**GE Nuclear Energy**

ABWR

Subject Chapter 14

Follow-up on Chapter 14 Open Items

Figure 14.2-1  
Power-Flow Operating Mzp and Testing Plateau Definitions

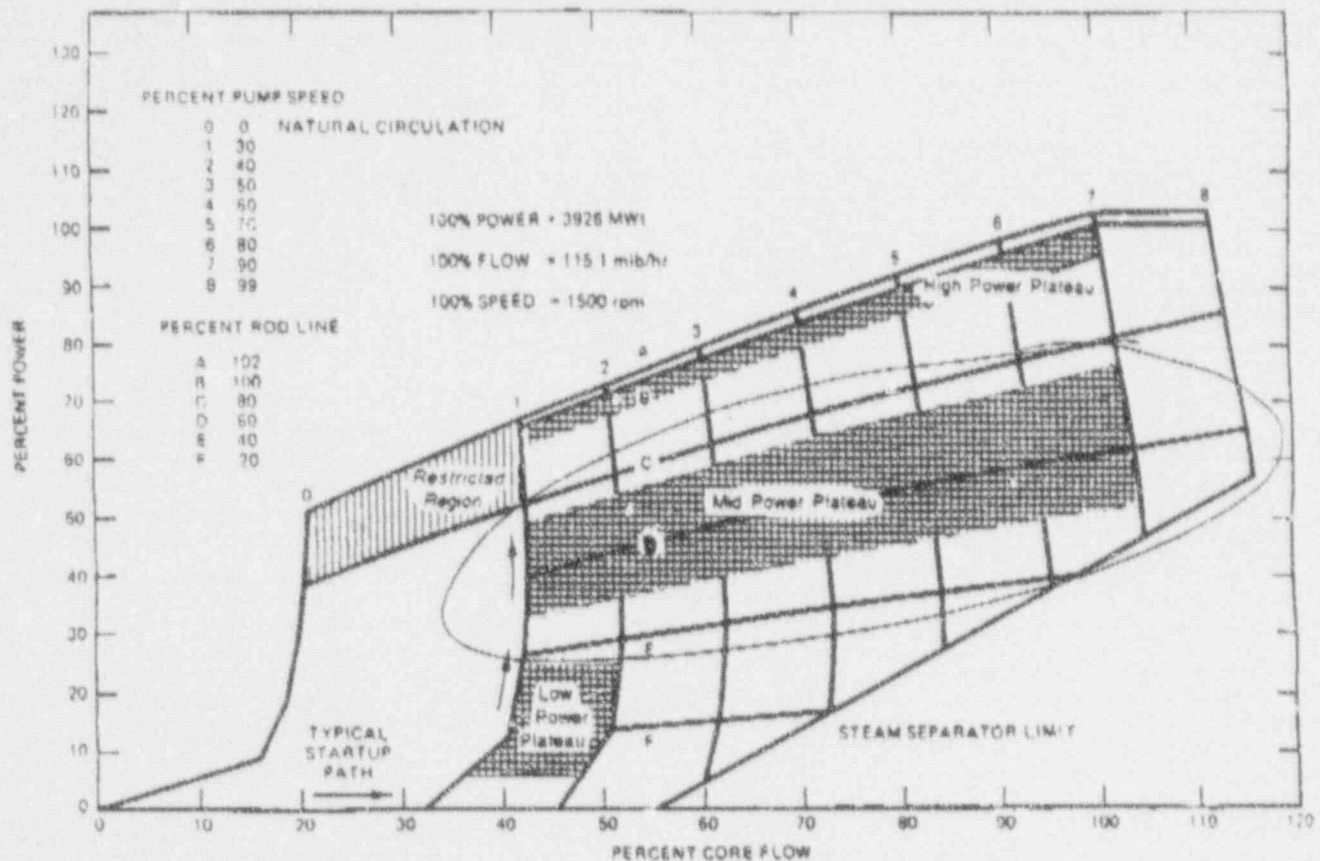
14.2-67 / Figure 14.2.1	Label 60% rod line D	Done, see revised figure
Various [DSER Item 124]	Trail from subsection 1A.2.4 (item I.G.1 of NUREG 0737) to Chapter 14 - Appendix E of BWROG response dated 2/4/81 committed to additional testing	Done, see revised text in subsection 1A.2.4 - operator training and initial testing issues have been more specifically delineated and a more specific cross reference has been provided to Chapter 14; cross references back to 1A.2.4 have also been added to the referenced subsections in Ch. 14
Various [DSER Item 125]	Incorporation of RG 1.56 into subsections 14.2.12.1.19, 14.2.12.1.54 and 14.2.12.2.21	The referenced subsections describe testing of systems that help control reactor water chemistry whereas RG 1.56 is concerned with the ability to monitor and verify acceptability of reactor water chemistry. Therefore, subsections 14.2.12.1.22 and 14.2.12.2.1, which describe testing of the equipment used for such monitoring and verification, have been revised instead to make specific reference to RG 1.56 requirements.
